Field Safety Notice

Heron toilet and bath chair manufactured by R82 A/S

Corrective Action: Retrofitting of gas spring head on Heron from R82 A/S

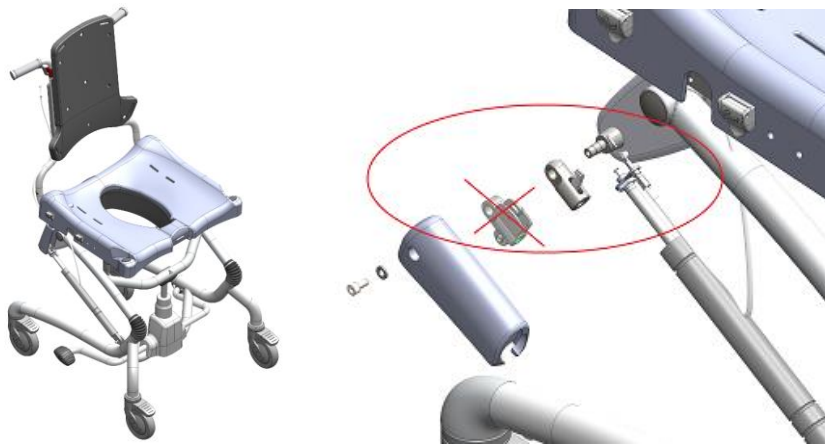
We have been informed about breakage of the aluminium gas spring head for the tilting mechanism on the Heron. This particular part was changed to a stainless steel version as of January 2016 and we are now undertaking a voluntary measure of sending out kits for replacement on units that still have the aluminium version to eliminate the risk of other breakages.
